Project: 90009590 - I-405 - Brickyard to SR527  
 Bothell, Washington 98011

## BY-CRE-03798\_009727\_RFI\_00627\_16.03.02\_BRT Below Grade Waterproofing Revisions Missed Prior to RFC

Washington State Department of Transportation  I-405, Brickyard to SR 527 Improvement Project Contract No. 009727	Doc Type: RFI
		REV#: 0
		SPEC SECTION:
		DATE: 10/22/2025
		CRE #: BY-CRE-03798

**FOUNDATION WALL DETAIL BETWEEN ELEVATOR PIT AND BACK-FILLED SPACE** 2  
 SCALE: 1" = 1'-0" BT230-AVX100

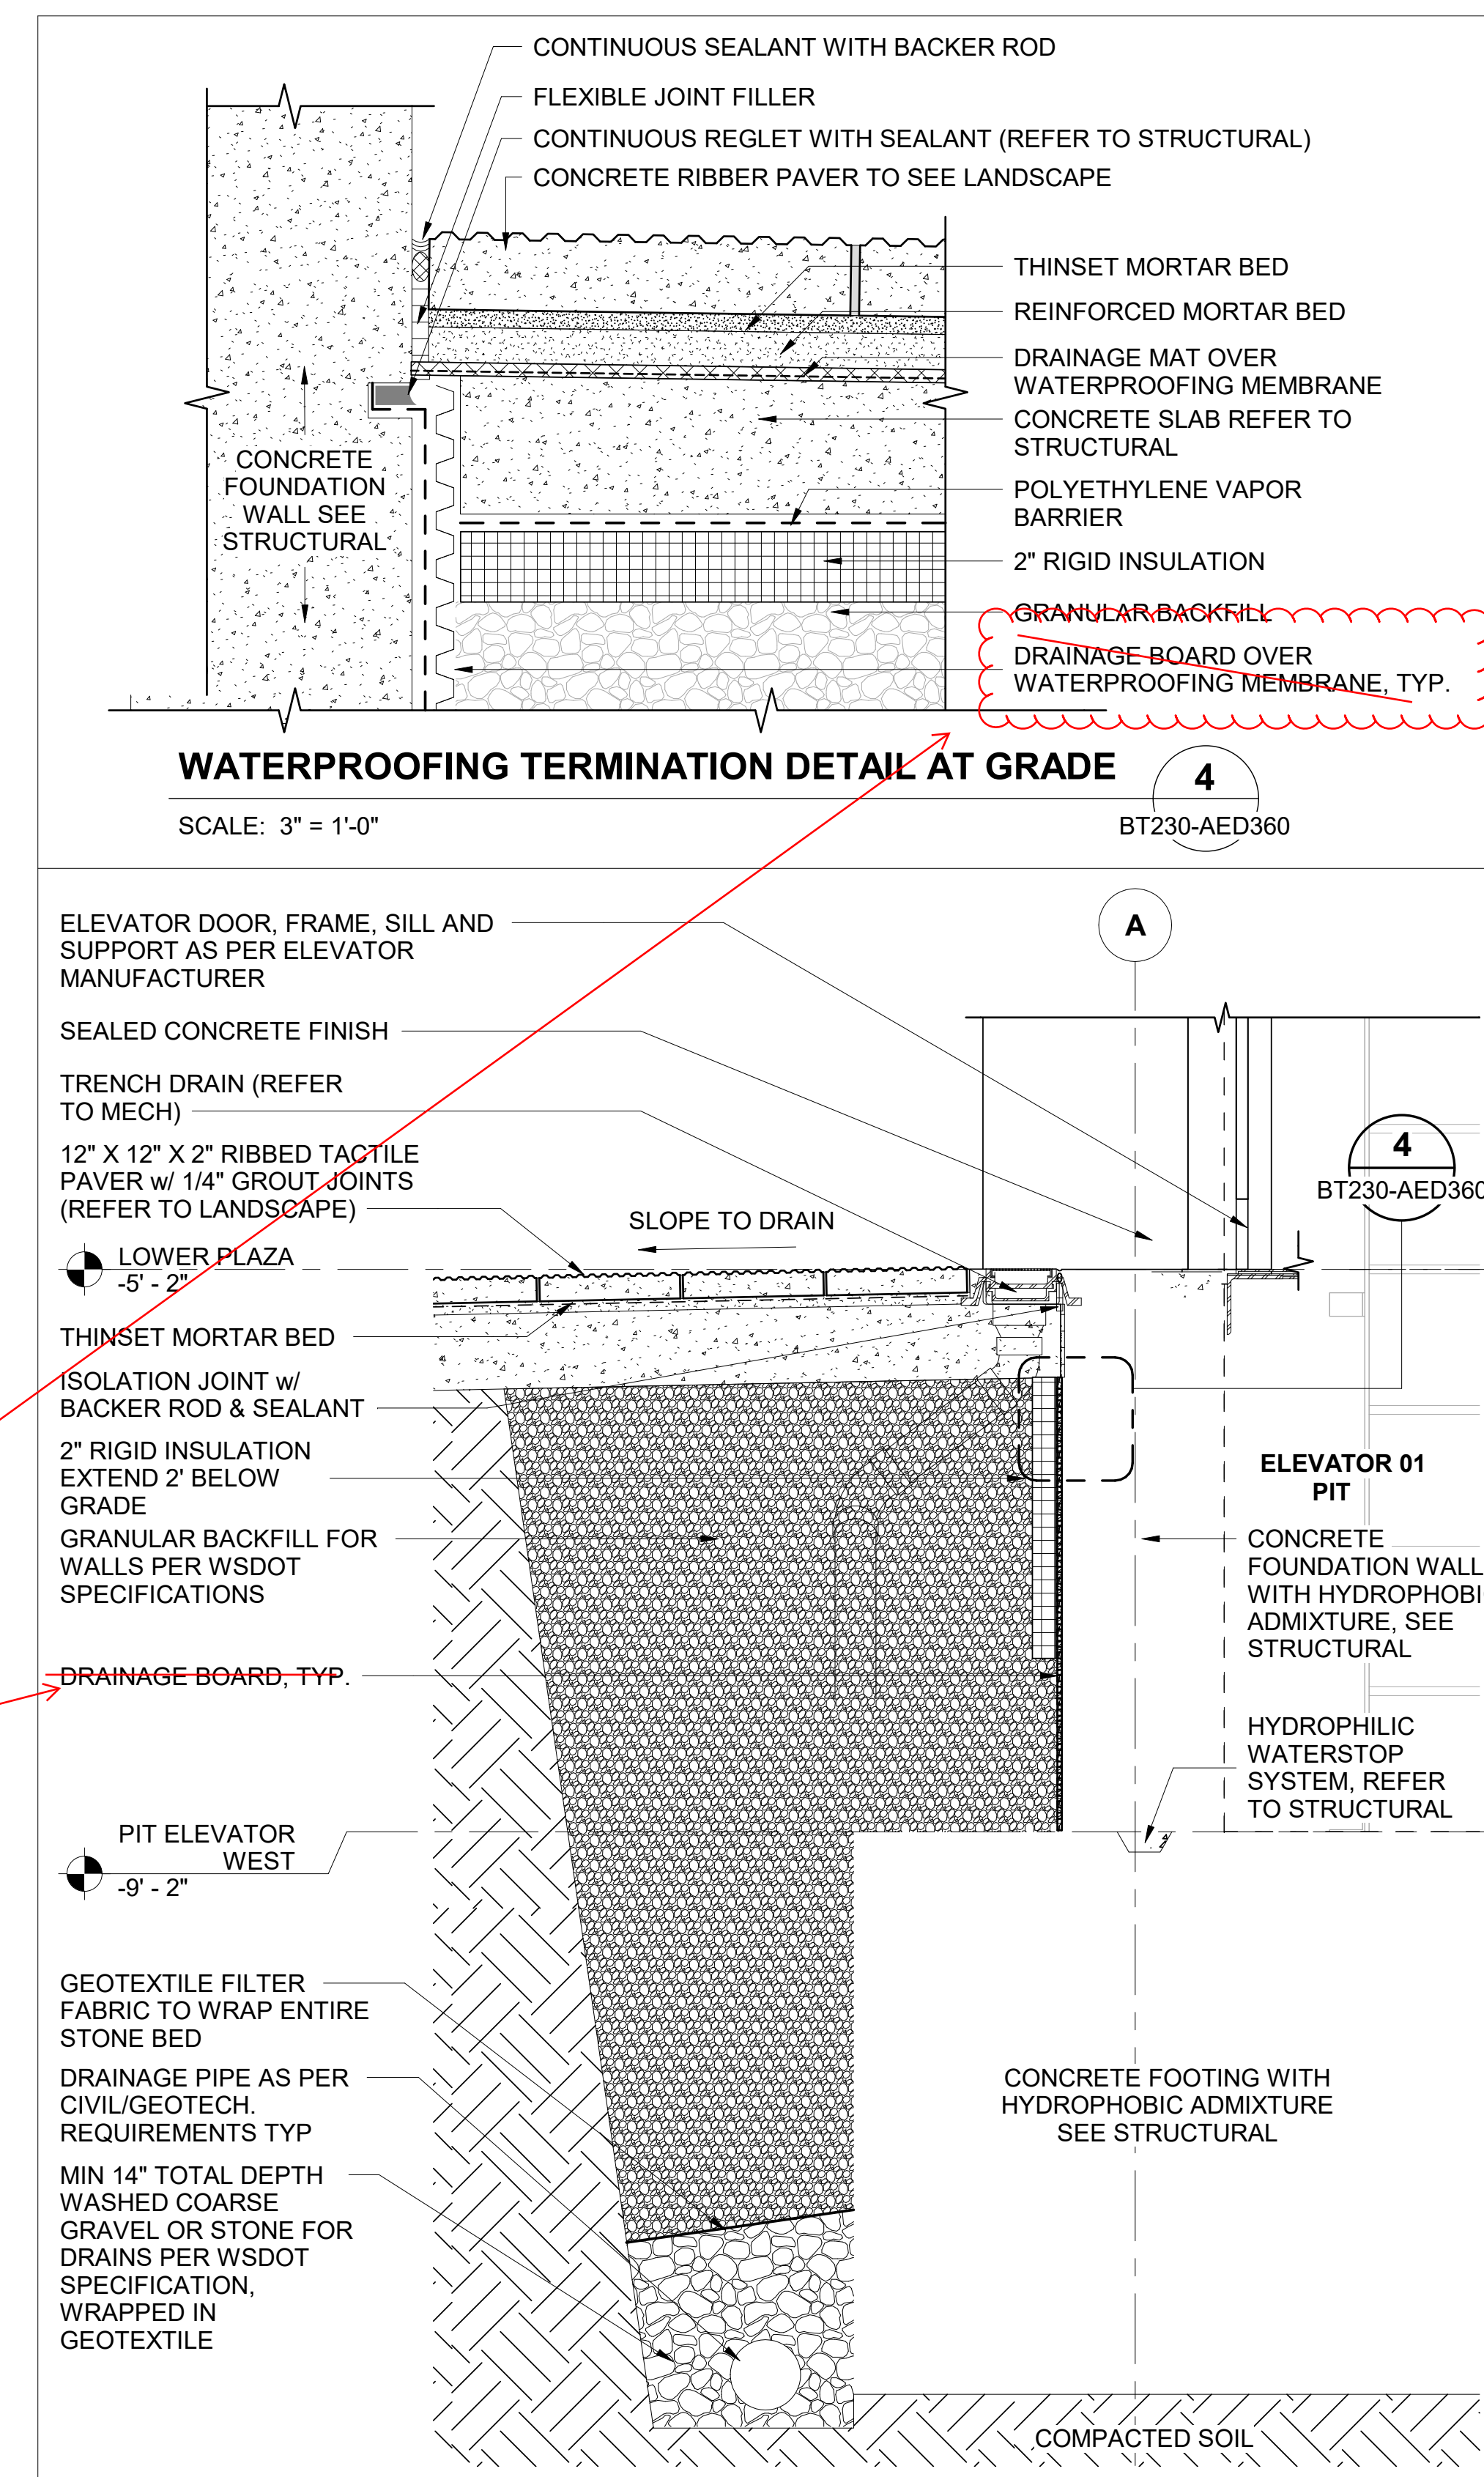
Q. AECOM please confirm all below grade waterproofing that has been marked on the attached drawings should have been removed prior to RFC.

**AECOM response:** Yes, waterproofing should be removed in marked up areas to be consistent with section AVX150 and AEX series where the waterproofing was omitted.

Please note the rigid insulation R-10 still should be extended 2' below grade as indicated.
